BICYCLE & PEDESTRIAN ADVISORY COMMITTEE

SUBJECT: Bicycle Technical Guidelines Update- Five New or Expanded Topics

Attachment A
Edits to be Consistent with the
2009 MUTCD & 2012 CA MUTCD

Figure 5-3:
Double Right-turn Lane

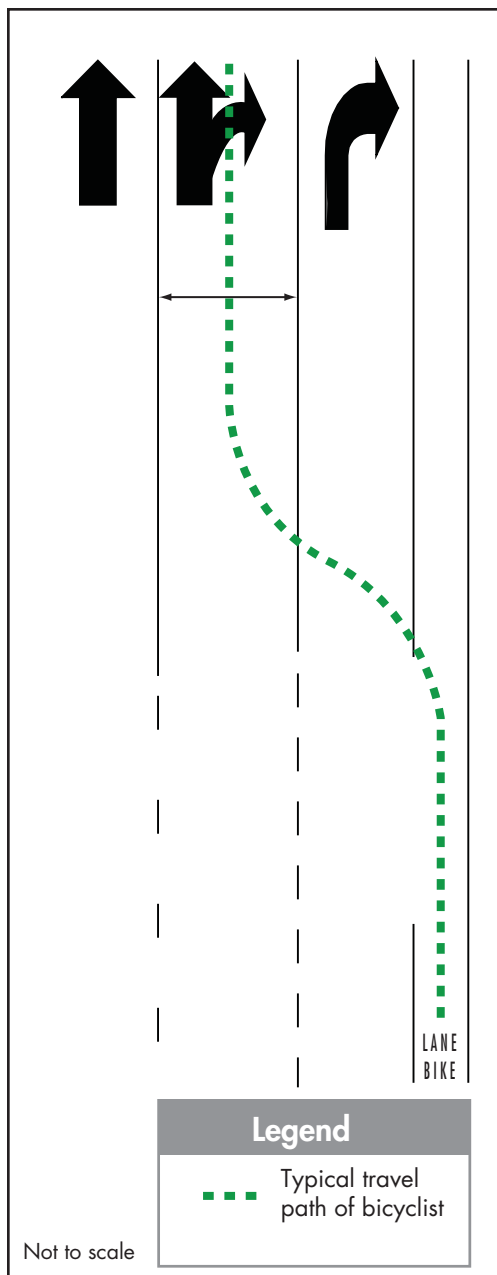
Dual right-turn lanes should be avoided particularly on roadways with bike lanes and on signed bike routes. Shared through and right-turn lanes adjacent to right-turn only lanes should also be used sparingly and should not be used on roadways with bike lanes since a bike lane cannot be striped up to the limit line with this configuration. If the shared through and right-turn lane is greater than or equal to 15 feet wide as shown in Figure 5-3, the situation is slightly ameliorated, but not solved. Fifteen feet provides enough space for the cyclists and the motorist to share the same lane side by side, but does not solve the inherent conflict of this design. Consider the Sharrow pavement marking described in Section 7.3 and MUTCD-CA Section ~~9C.103~~. 9C.07.

Figure 7-12:
Typical Sharrow Pavement Marking Installation

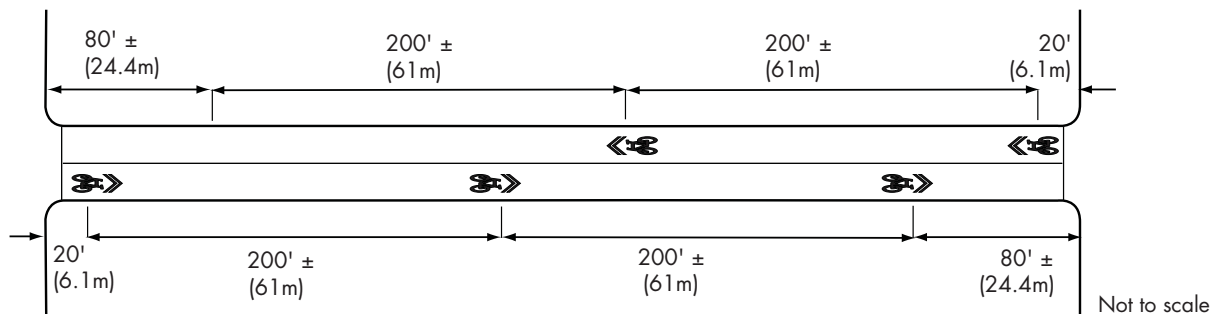
- Lateral placement: centerline of symbol should be 11 ft (3.3 m) from edge of curb where there is on-street parking.
- Longitudinal placement: immediately after an intersection and every 250 feet (75 m).

▶ ~~MUTCD CA states that the lateral distance may be increased as needed for roadway and traffic conditions.~~

○ - Where there is no onstreet parking, the center line of the symbol should be at least four feet from the face of curb, or edge of pavement when there is no curb.

For roadways with no parking, centerline of symbol should be ~~2.5 ft min. (0.8 m) from the curb face or~~ 2.0 ft min. (0.6 m) from gutter lip.
